Access Compliance Report

Public Rights-of-Way

(Curb Ramps)

Intersection ID: 3340	Main Street: HUCKS_RD	Cross Street: CANIPE_DR	Location: SE
ADA ID: 067C211F4F00	Ramp Type: Perp	Initial Pass/Fail: Fail	Overall Compliance: No
Codes/Mitigation Info/Possible Solution		Field Measurements/Component Compliance	
Severity Score: 21.25

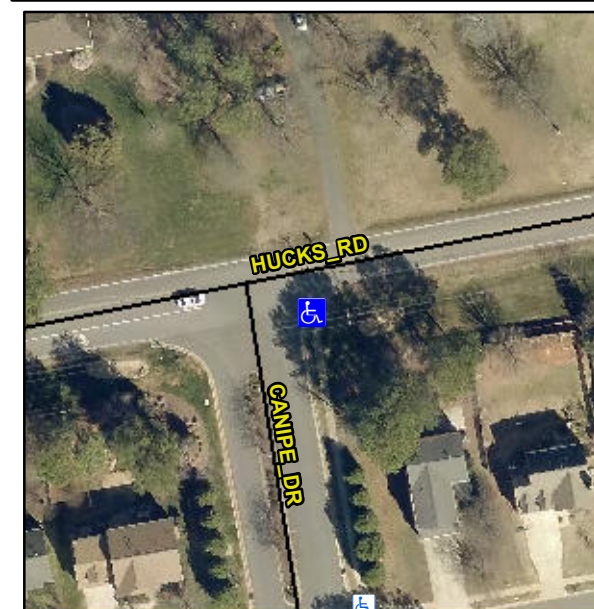
Not Found, R304.5.1, R304.5.3

Compliance	Description	Data	Compliance	Description	Data
N/A	Ramp Length (in)	48.5	Yes	Ramp Slope (%)	8.0
No	Ramp Width (in)	42.0	No	Ramp XSlope (%)	5.7
N/A	Flare Type LT	N/A	N/A	Flare Type RT	N/A
N/A	Flare Slope LT (%)	N/A	N/A	Flare Slope RT (%)	N/A
N/A	Flare Traversable LT?	N/A	N/A	Flare Traversable RT?	N/A
N/A	Landing Length (in)	N/A	N/A	DWS Provided?	N/A
N/A	Landing Width (in)	N/A	N/A	DWS Contrast?	N/A
N/A	Landing Slope (%)	N/A	N/A	DWS Length (in)	N/A
N/A	Landing X Slope (%)	N/A	N/A	DWS Full Width?	N/A
N/A	Landing Curb? (Y/N)	N/A	N/A	DWS Offset (in)	N/A
N/A	Shared Landing?	N/A			
N/A	Gutter Ponding?	N/A	N/A	Gutter Slope (%)	N/A
N/A	Gutter Lip Ht (in)	N/A	N/A	Gutter X Slope (%)	N/A
N/A	Painted X Walk1?	No	N/A	Painted X Walk2?	N/A
	X Walk 1 Direction	To N		X Walk 2 Direction	N/A
N/A	X Walk 1 Width (in)	N/A	N/A	X Walk 2 Width (in)	N/A
	X Walk 1 Slope (%)	9.7		X Walk 2 Slope (%)	N/A
	X Walk 1 X Slope (%)	3.1		X Walk 2 X Slope (%)	N/A

Remove & Replace Entire Ramp.
